Item 8 - Correspondence

RE: Administrative Subdivision M-NCPPC FILE No. 62020008A
5310 Moorland Lane and 5314 Moorland Lane ("Subject Property")

Re: Stormwater Management and Downstream Drainage Review and Comments
Administrative Subdivision #62020008A
Stormwater Management Concept Plan #287159
5310-5314 Moorland Lane and 7507 Glenbrook Road - Bethesda, MD 20814
O'C&L Project #021-024

MNCPPC FILE #62020008A
SWM CONCEPT & SITE DEVELOPMENT PLAN
5310 / 5314 MOORLAND LN.
WSSC: 209NW05 MAP / GRID: HN12
EDGEMOOR-LOT 21 & P/O LOT 2, BLOCK 8
BETHESDA (7th) ELECTION DISTRICT
MONTGOMERY COUNTY, MARYLAND

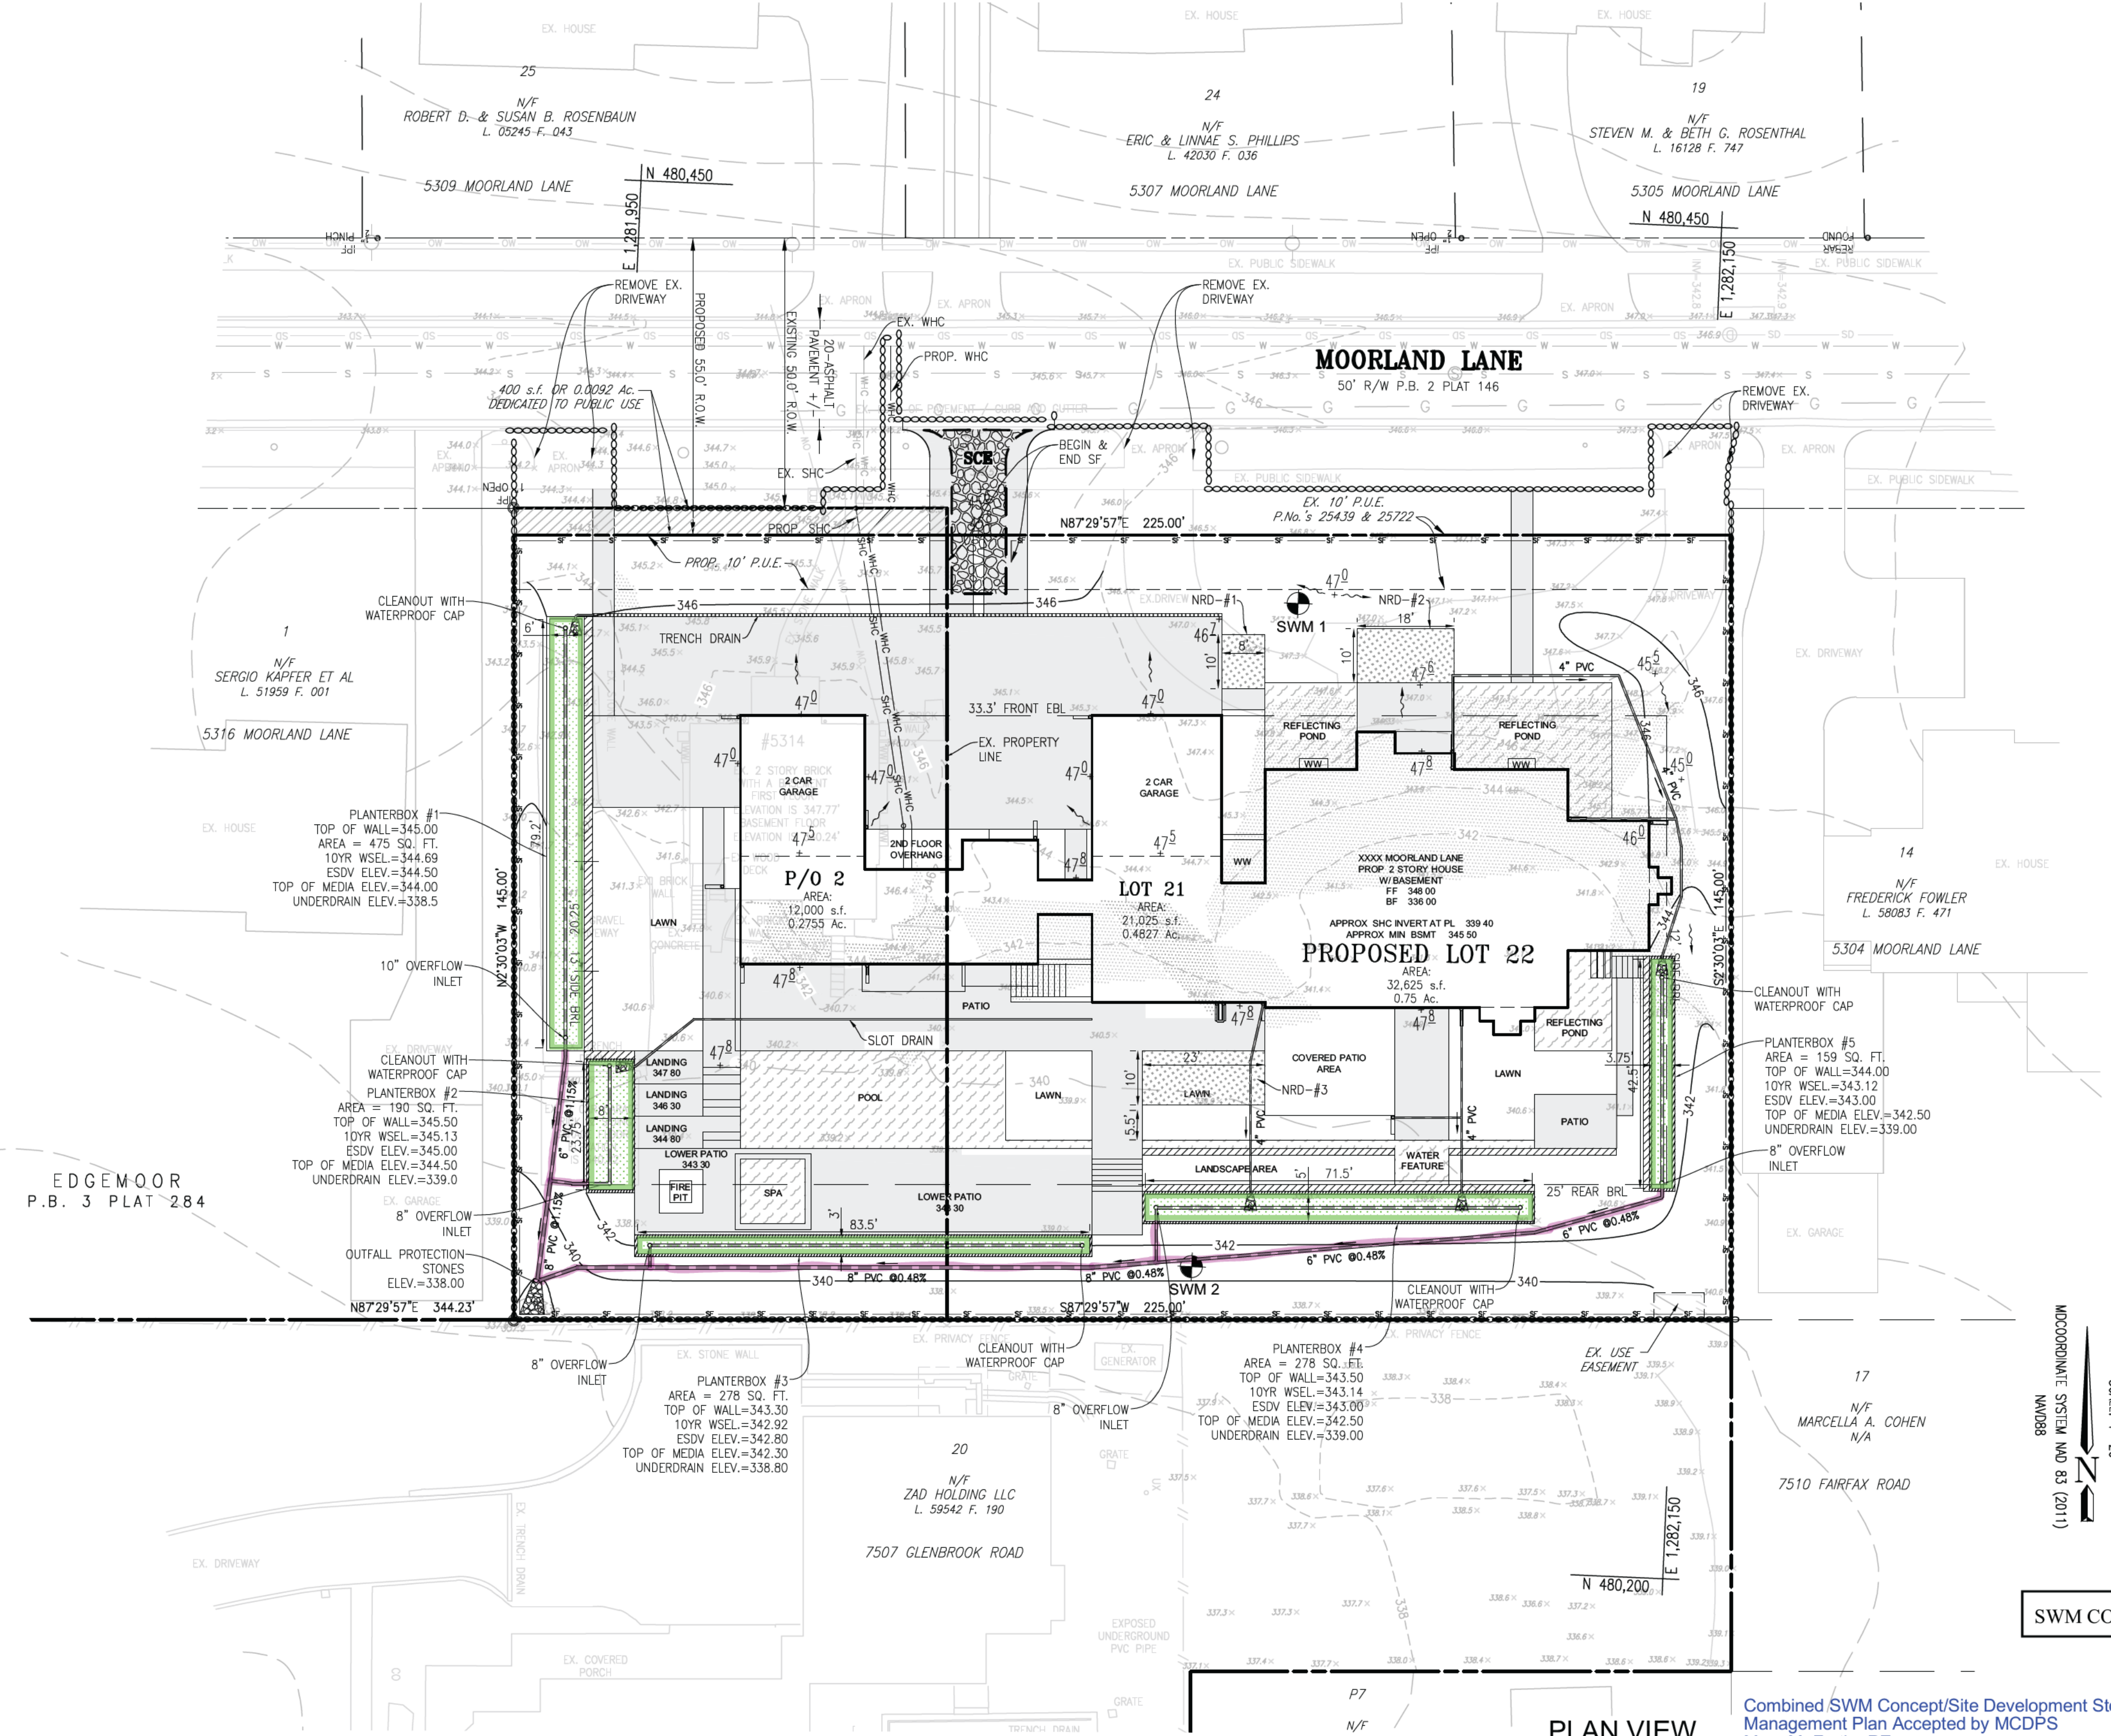
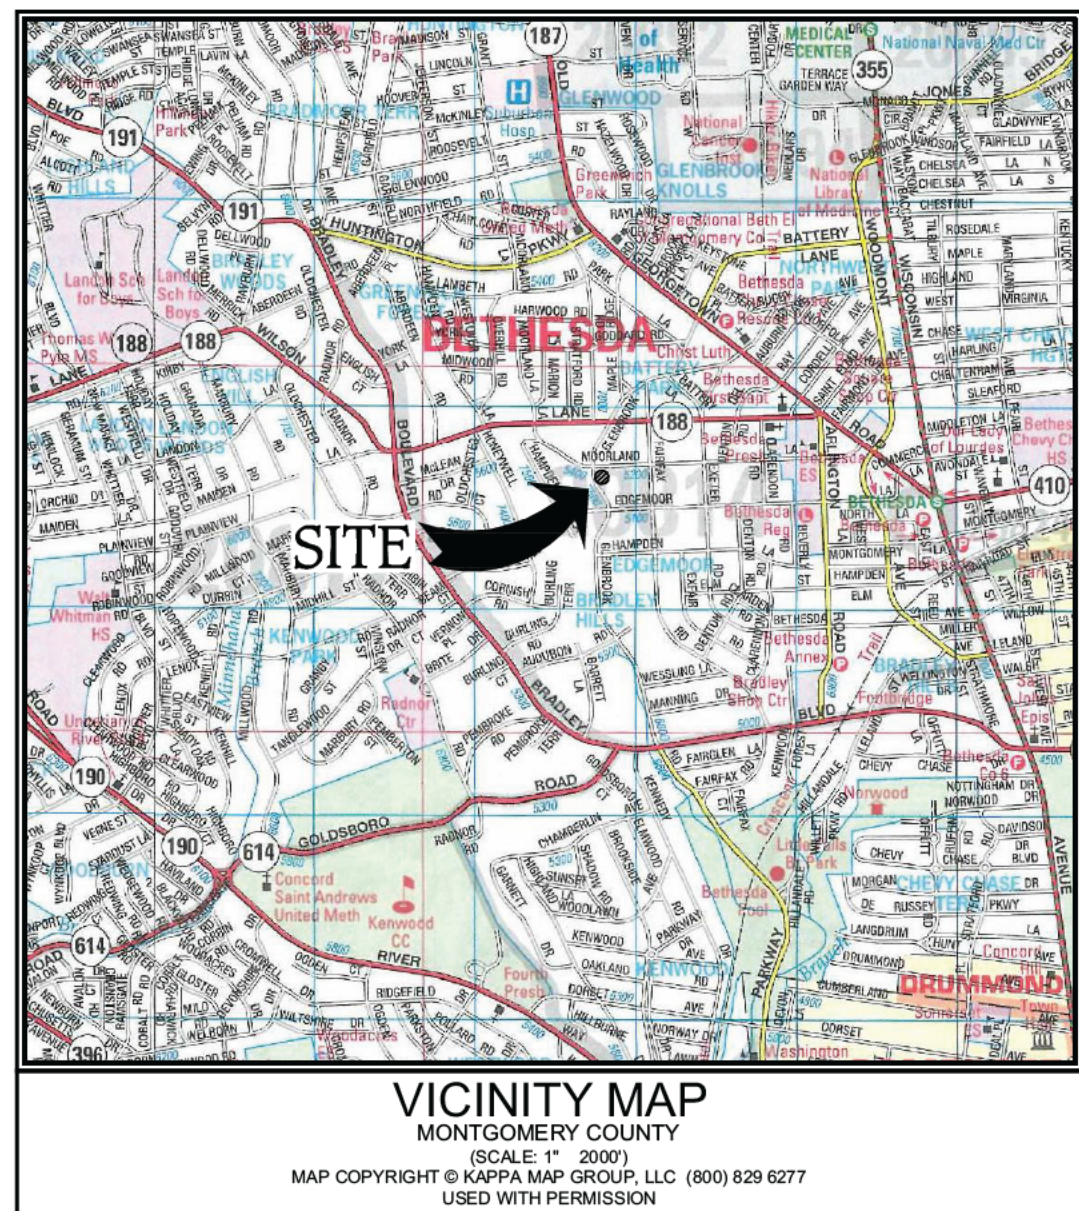
The Approved Concept Plan shows a series of five (5) Microbioretention Planter Boxes located generally along the side and rear walls of the proposed house or adjacent lawn/patio areas. Runoff reaches the individual planter boxes in a variety of ways, including trench drain, rooftop downspout, and direct overland flow. The outfall piping from each of these Microbioretention Planter Boxes is directed to an area of “Outfall Protection Stones” generally located at the southwestern corner of the lot, adjacent to 5316 Moorland Lane. The Approved Concept Plan notes that the Outfall Protection Stones, a term generally considered to be analogous to a rip-rap pad, are proposed to be established at an elevation of 338.00.

First, O’C&L recognizes that the discharge location as shown on the Approved Concept Plan directs runoff from the Microbioretention Planter Boxes to a location very near to the property line directly between 5314 Moorland Lane and 5316 Moorland Lane.

Second, O’C&L recognizes the Approved Concept Plan shows two (2) separate outfall pipes

discharging at the outfall protection stones. Both proposed pipes are 8" PVC pipes. One of the two pipes is proposed to collect drainage from Microbioretention Boxes 3, 4 and 5; O'C&L believes it would be quite simple and possible from a technical standpoint to discharge runoff from these boxes well east of the proposed discharge location. It is O'C&L's opinion that the outfall piping from these three planter boxes could easily be set such that it discharges directly to the south of Planter Boxes 3 and 4, to an undeveloped area (per plan) behind the house at 7507 Glenbrook Road, a property that is already part of the Subject Application.

Most importantly, O'C&L has significant concerns about the downstream topography in the vicinity of the proposed outfall location from the planter boxes. The various types and versions of plan sets reviewed by O'C&L show inconsistent information about the topography directly downstream from the outfall point. In particular, the Approved Concept Plan shows a proposed contour line at a 338 elevation that generally appears to be designed to wrap around the outer face of the outfall protection stones and form a concentrated channel at/near the outfall pipe from the discharge pipes. An existing 338 contour is shown both on the property at 5314 Moorland and, apparently, just to the south of the property line, on 7507 Glenbrook. Further, existing spot grades at/near the southwest corner of 337.9 and 337.8 are also shown in this location. Consequently, this area, per the proposed and existing contouring shown on the Approved Concept Plan, shows that runoff is directed to a low spot that has no obvious relief path and will concentrate and pond on the property at 5316 Moorland Lane.
